**LEESBURG BOARD OF ARCHITECTURAL REVIEW
STAFF REPORT**

**REGULAR MEETING: 19 NOVEMBER 2012
AGENDA ITEM 4b**

BAR Case No. TLZM-2012-0005: New construction of a service station, convenience store and car wash in a planned development.

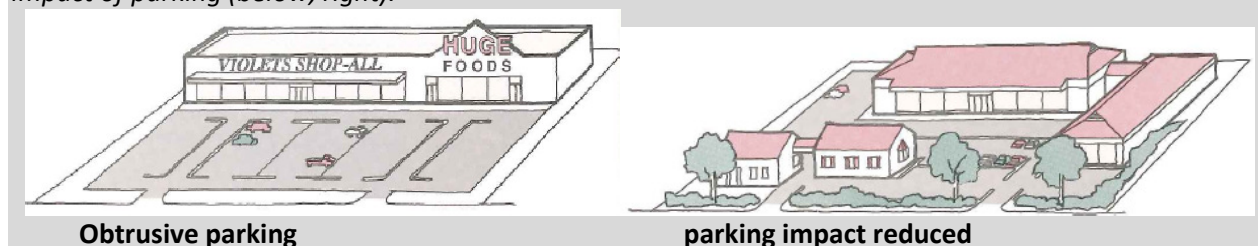
*P.16 Features that **Obscure or Destroy** human scale (to be avoided – 3 of the 7 listed apply):*

1. *Blank walls*
The blank walls should be detailed to a human scale or screened.
2. *Smooth or panelized building materials (stucco, metal or prefabricated concrete panels)*
The smooth stucco on the rear and side should be detailed to a human scale or have the materials altered.
3. *Flat (not visible) roofs*
The roofs should be compatible with the existing approved roofs in this development, all of which are gabled with shingles.

As can be seen by drawings of façade and gas pump canopies above, the façade will rise above the height of the canopies which will block its visibility and change the scale of the building in relation to the canopies which are already being requested to be higher than is normally allowed due to the slope of the site.

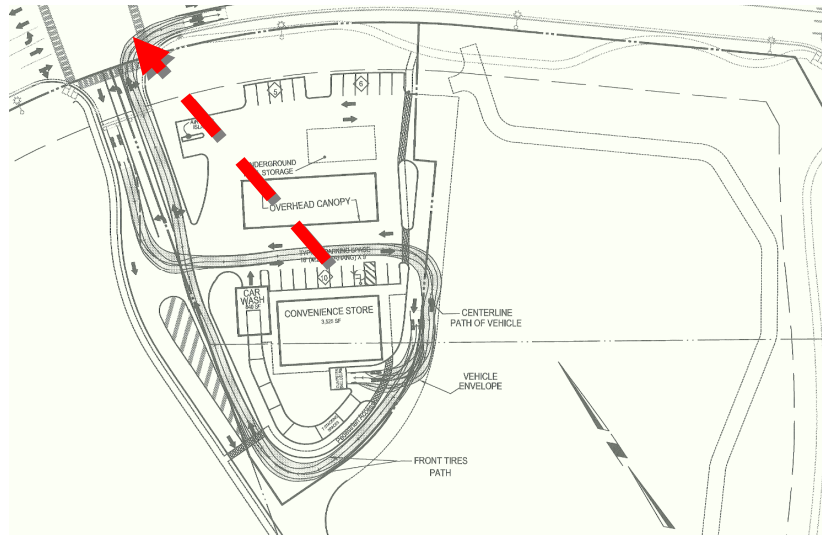
*A single large expanse of parking should be avoided. Instead, parking should be provided in smaller, well-defined areas, separated and screened by features such as berms, access drives, landscaping and/or buildings. Parking areas **should not** be located exclusively at the front of building sites.*

- ◆ Parking for this site is exclusively at the front of the site, which **is not to be done**.

- ◆ This site should have alternative parking placement using the rear and/or sides of the building for smaller parking areas.
